**RESOLUTION SETTING HEARING REGARDING REQUEST FROM STONEY POINTE CAR WASH, LLC (OWNER), REPRESENTED BY LLOYD D. LINN (OFFICER), FOR REVIEW AND APPROVAL OF A 2<sup>ND</sup> AMENDMENT TO THE STONEY POINTE PUD CONCEPTUAL PLAN, ON PROPERTY LOCATED AT 5901 SOUTHEAST 14<sup>TH</sup> STREET, TO ALLOW A RESTAURANT WITH A DRIVE THROUGH USE**

Communication from the City Plan and Zoning Commission advising that at their June 16, 2022 meeting, the following action was taken regarding a request from Stoney Pointe Car Wash, LLC (owner), represented by Lloyd D. Linn (officer), for review and approval of a 2<sup>nd</sup> amendment to the Stoney Pointe PUD Conceptual Plan on the property located at 5901 Southeast 14<sup>th</sup> Street, to allow a Restaurant with a drive through use.

## STAFF REPORT TO THE PLANNING COMMISSION

# Stoney Pointe Car Wash, LLC, 5901 Southeast 14th Street

**SITE ARCH. PLAN**

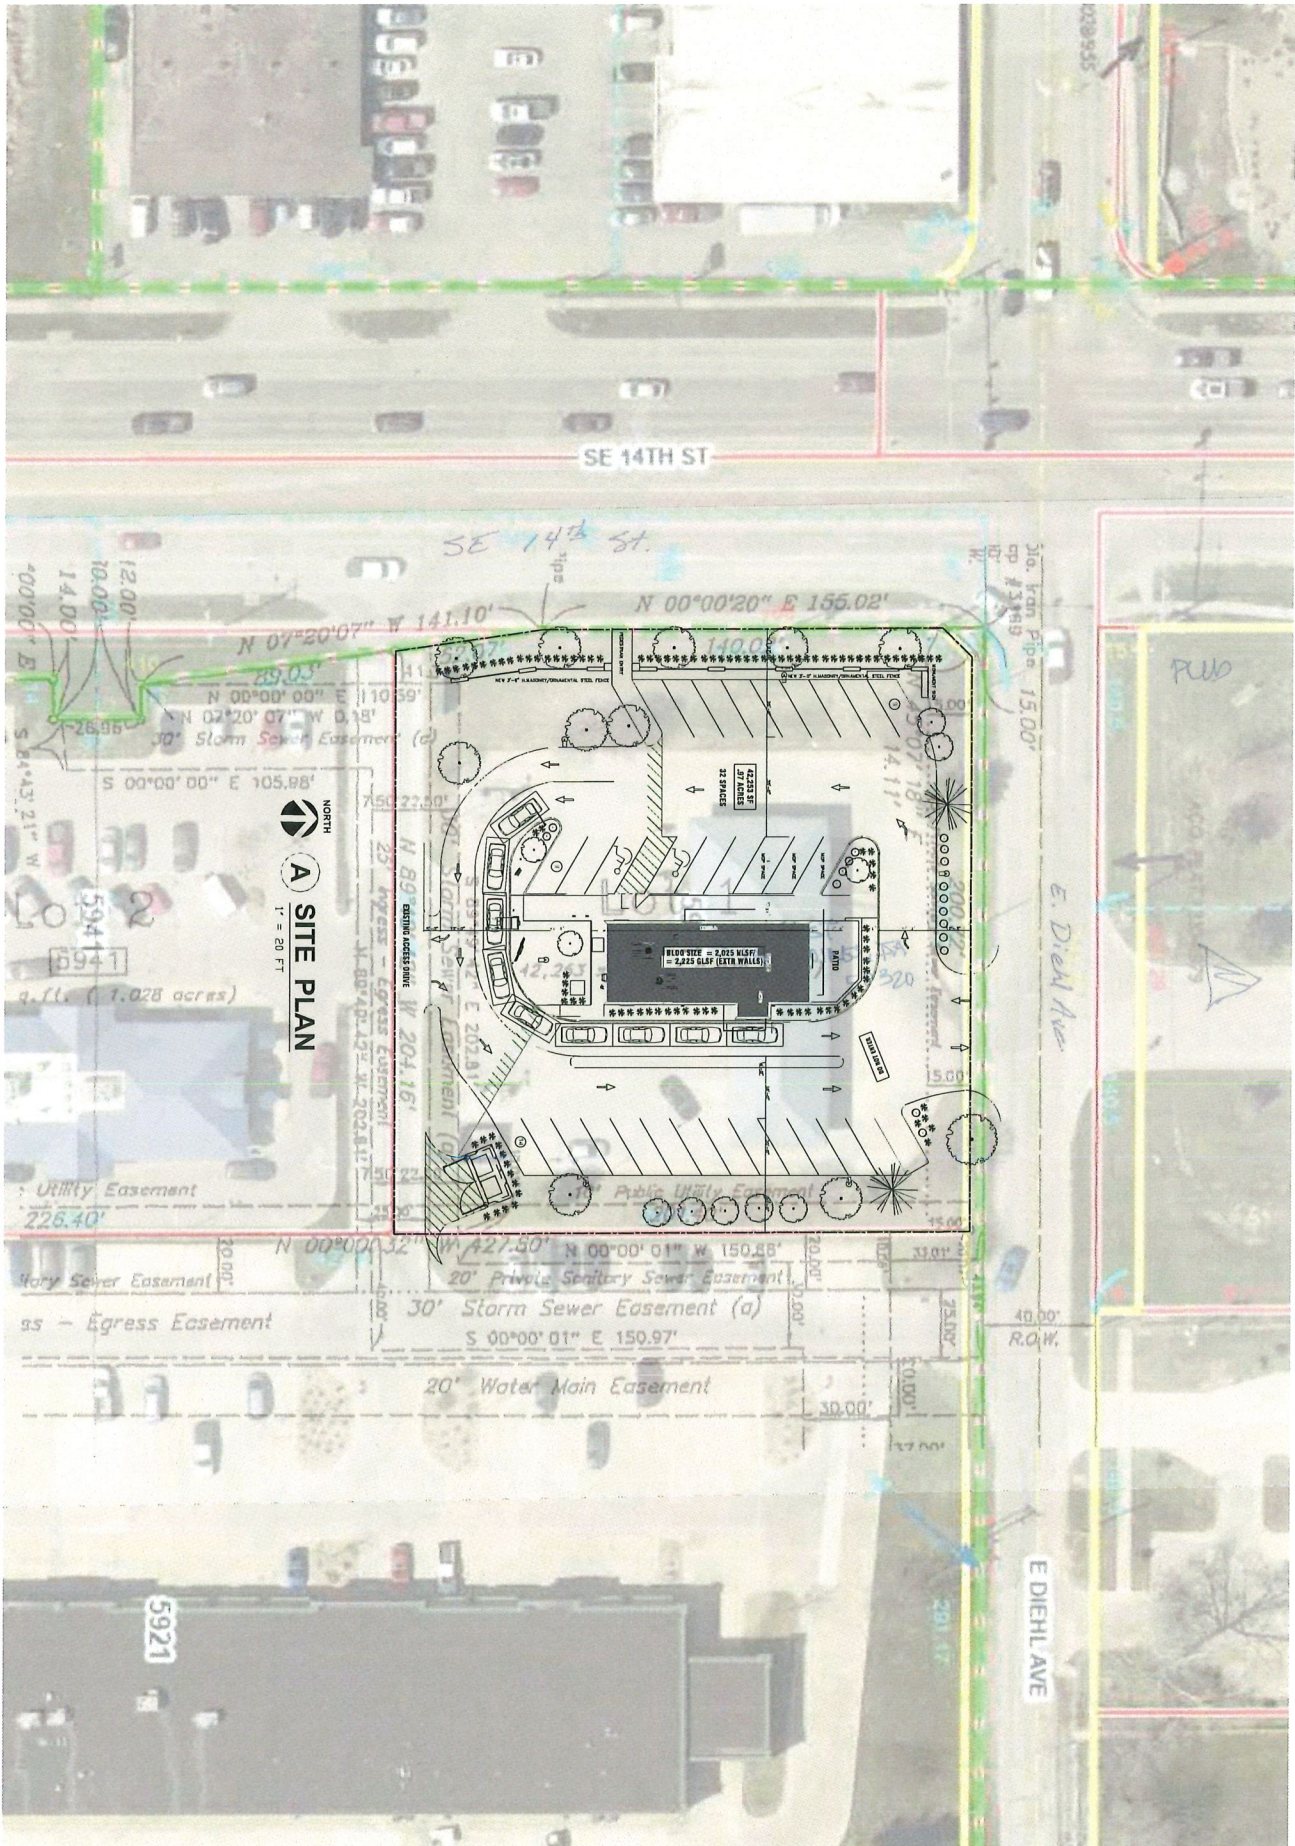
Staff suggests that the westernmost row of parking be shifted to the back side of the building. The landscape strip along SE 14<sup>th</sup> Street could also be slightly reduced. These two changes would allow the building to be shifted 25 feet closer to SE 14<sup>th</sup> Street than what is proposed. This would reduce the number of potential vehicle movements that a pedestrian would have to track as they enter the site from the SE 14<sup>th</sup> Street sidewalk.

The Conceptual Plan shows a proposed monument sign located at the northwest corner of the subject property (SE 14<sup>th</sup> Street and East Diehl Avenue). Staff recommends that any proposed non-building-mounted signage comply with Table 134-5.6-1 and Section 134-5.5.4 which states no more than one 75-square-foot monument sign per street frontage and a base height of at least two feet or 25% of the overall sign height, whichever is greater; a base width at least as wide as the sign face; and a sign base constructed of brick, stone, concrete block, or similar permanent, durable material complementing the exterior of the primary building on the lot.

1. Reduction in the building setback from SE 14<sup>th</sup> Street to the satisfaction of the Planning & Urban Design Administrator.
2. Any proposed signage shall comply with the requirements for the MX3 District.
3. Addition of the following notes on the “PUD” Conceptual Plan:
  - a) Development of the site must comply with the Tree Removal and Mitigation Ordinance contained in Chapter 42, Article X, of the City Code.
  - b) Any grading is subject to an approved grading permit and soil erosion control plan, as well as a Stormwater Pollution Protection Plan (SWPPP) approved by the Iowa DNR.
